FINAL ENVIRONMENTAL IMPACT REPORT

EIR No. 96-0090-SUB(ZV)(CUB)(DA)
STATE CLEARINGHOUSE No. 96051050

Vesting Tentative Tract No. 52172

HARBOR GATEWAY CENTER

**Figure 31
Existing and Proposed
Sewer System**

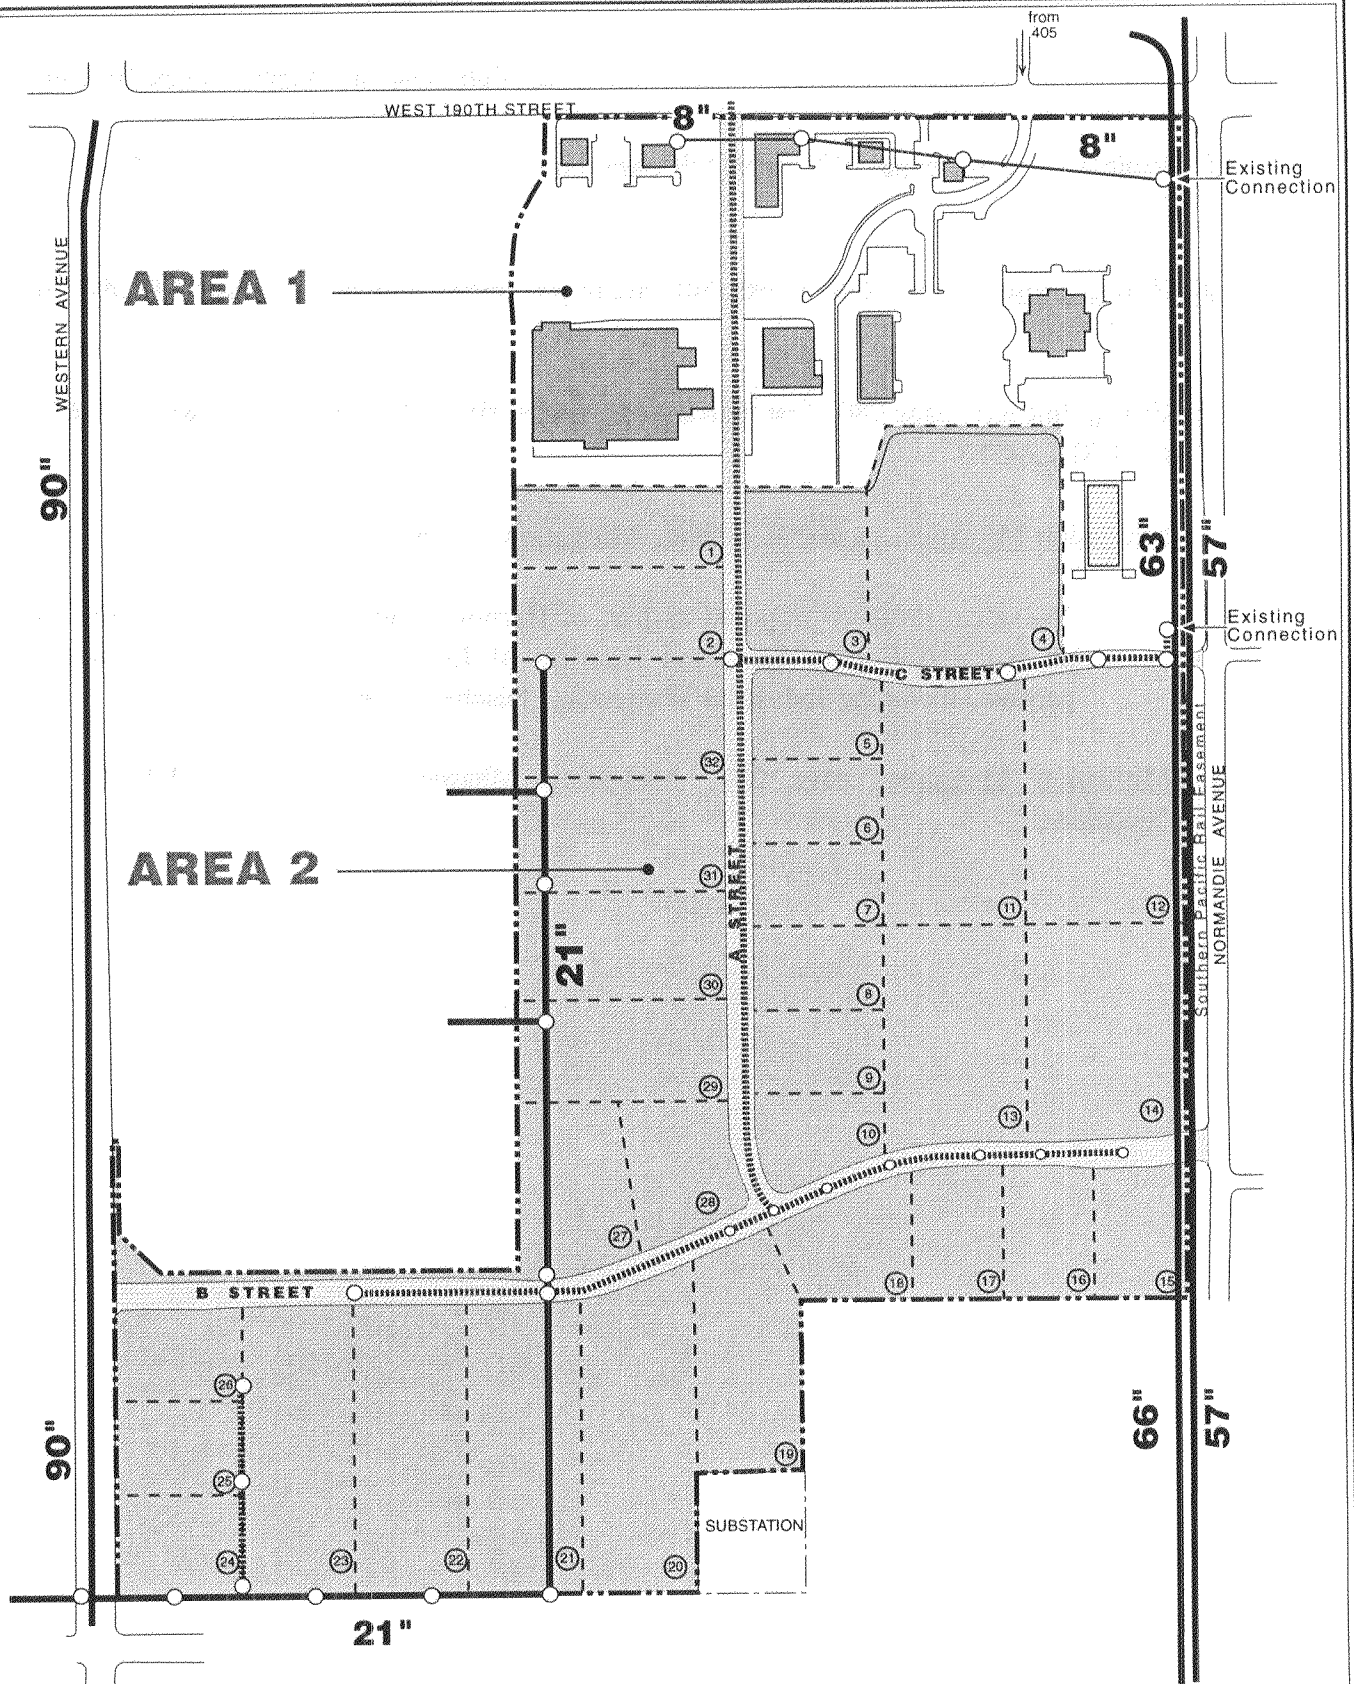
- c. Environmental Setting, page 278, revise Figure 31 as shown on page 71.
- d. Environmental Setting, page 279, add the following after the first (partial) paragraph:
